# RYAN DEVELOPMENT LLC

**RE: Special Permit and Site Plan Special Permit Applications  
252-256 Main Street, Acton, MA**

In light of the above, the Applicant submits the following supplemental responses to the Board of Selectmen along with the attached plans entitled "Site Plan for 110 Grill Restaurant, 256 Main Street (Route 27), Acton, MA" revised through 12/3/15 along with revised Architectural Renderings.

**SITE PLAN**  
**GRADING, DRAINAGE, AND UTILITY PLAN**

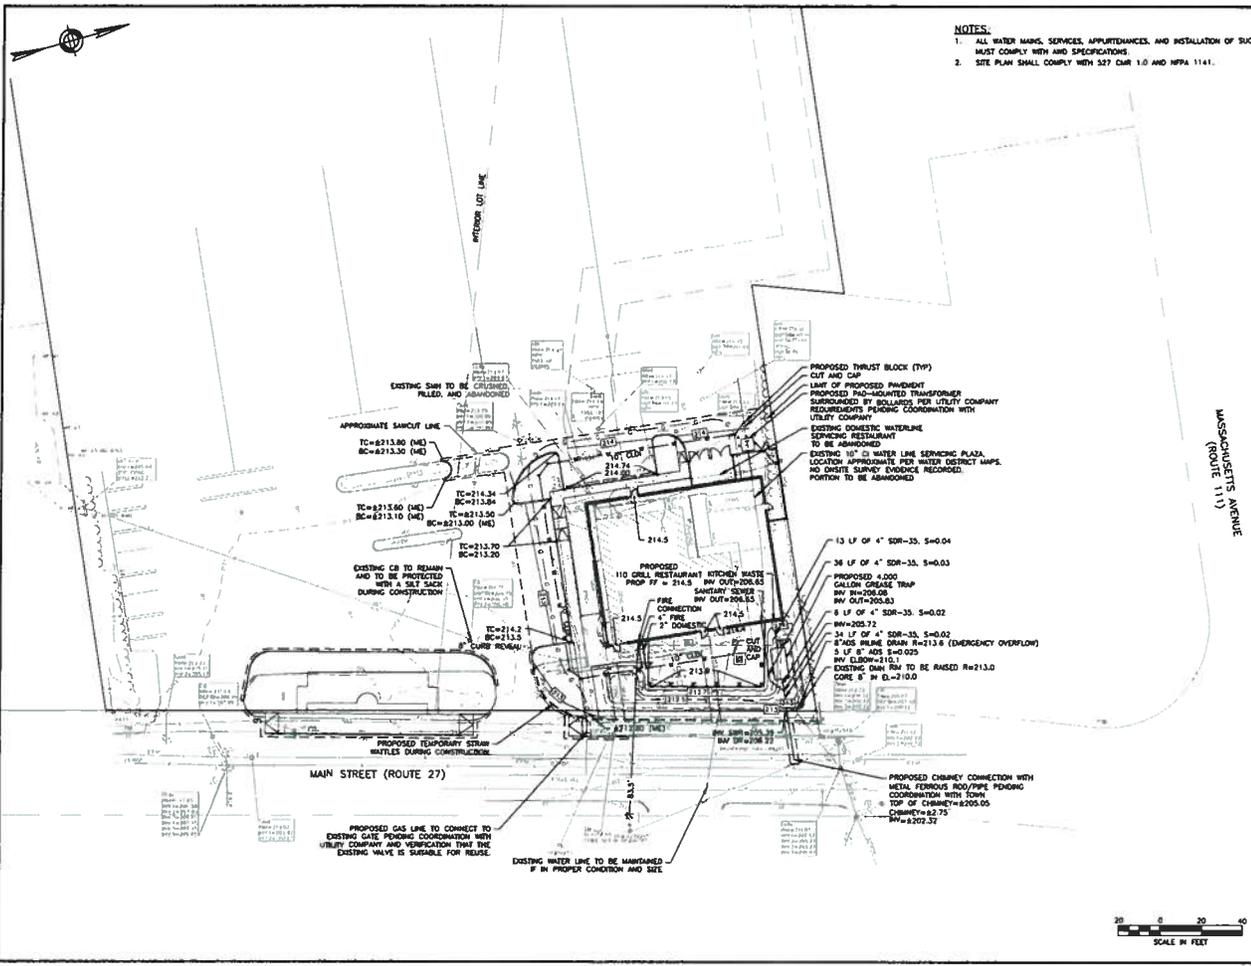
- a. *“Pedestrian plazas shall be located in front of the building or on the side of the building. The pedestrian plaza is currently located as an island; the pedestrian plaza is surrounded by two access drives and a parking lot. As stated at the public hearing, the pedestrian plaza should be relocated so that it is on the side of the building. Revised plans should also show changes to the parking calculations.”*

5. *"The modified parking lot along the south side of the proposed building is located +/-20ft from the property line where a 30ft setback is required under ZBL S. 6.7.2. The parking space closest to the street should be removed."*

*"Although the location above has been modified to comply, the 10-foot wide perimeter landscape buffer has been removed and a pedestrian plaza has been placed next to the parking lot cells. The Applicant should amend the plans by adding a 10-foot wide perimeter landscape buffer to boarder the parking lot cells. A pedestrian plaza cannot count towards the required 10-foot wide perimeter landscape buffer. Parking calculations should be revised to show changes."*

**Reponse:** The plan has been revised to provide bicycle parking accessible from the vehicle parking lot and outside of the pedestrian plaza. It is also located near the main entrance of the building. The plan as revised complies with ZBL S. 6.3.7.

**Response:** The plan has been modified to remove the parking space closest to the street. Accordingly, the plan as revised complies with ZBL S. 6.7.2.

**Response:** The Plan has been modified to add a 10 foot wide perimeter landscape buffer to boarder the parking lot cells referenced in the comment above. As revised, the plan fully complies with this requirement. The parking calculations on the Site Plan have been updated to reflect the corrected number of parking spaces located on the Property.

**4,000 GALLON GREASE TRAP DETAIL**  
 NOT TO SCALE

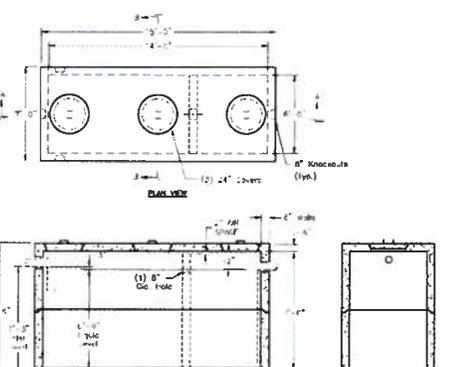
4. *"The grease trap is located beneath the drainage swale which is sized to infiltrate the 100-year storm. The grease trap may be located below the seasonal high groundwater level. If so, the applicant should check the buoyancy of the grease trap. A copy of the buoyancy calculations should be made available to our department and Health."*

**Response:** The Applicant will comply during the building permit process.

**SITE PLAN**

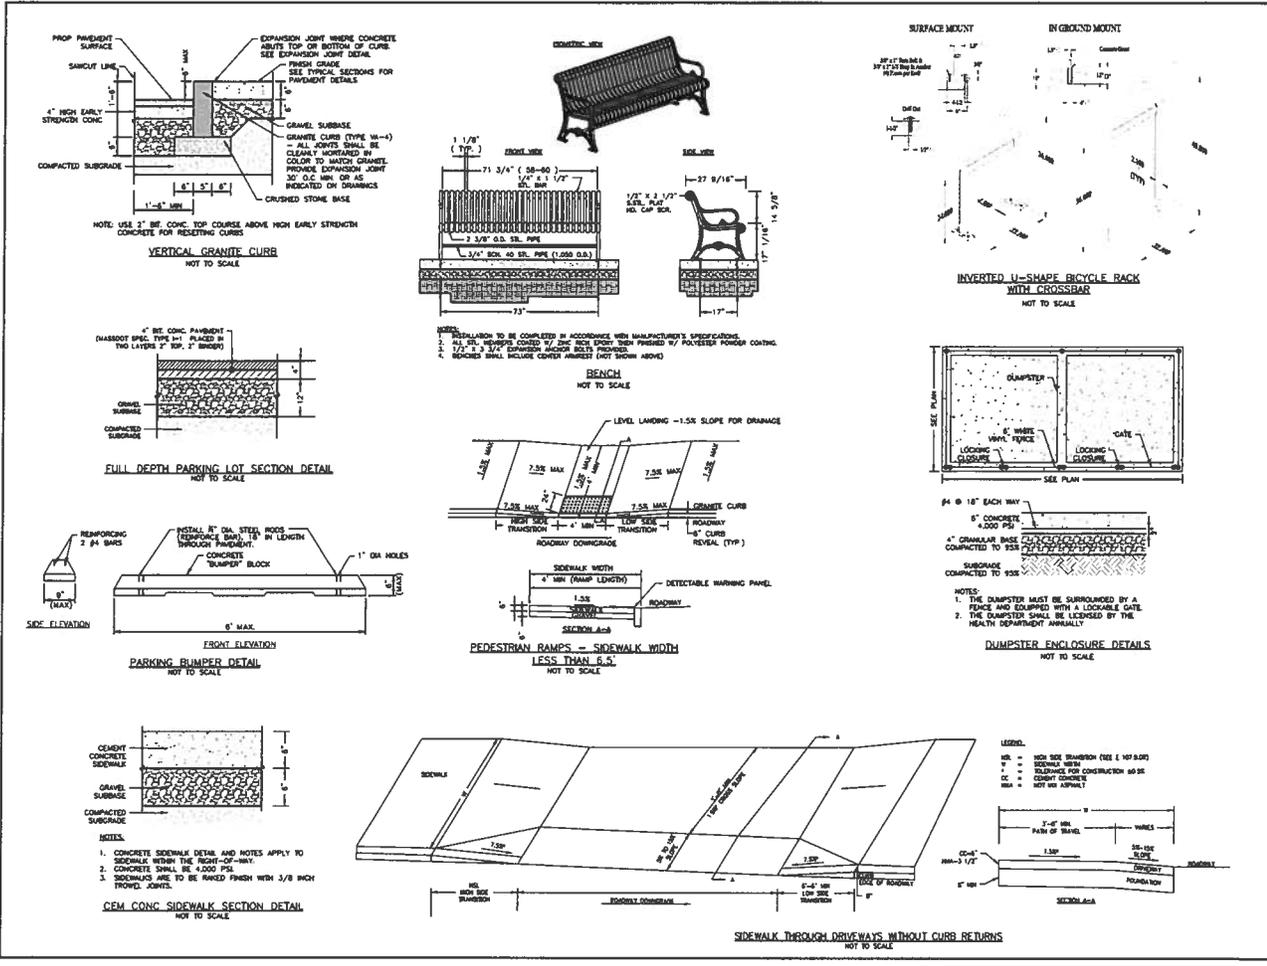
8. The landscape plan has not been revised, and no plantings have been added to screen the north wall as suggested. The neighboring lot has trees along this border which will partially screen; the addition of shrubs on the 110 Grill lot in this location is recommended. The remainder of the plans seems appropriate for the space and use.

**Response:** The landscape plan has been revised to add plantings per this comment.
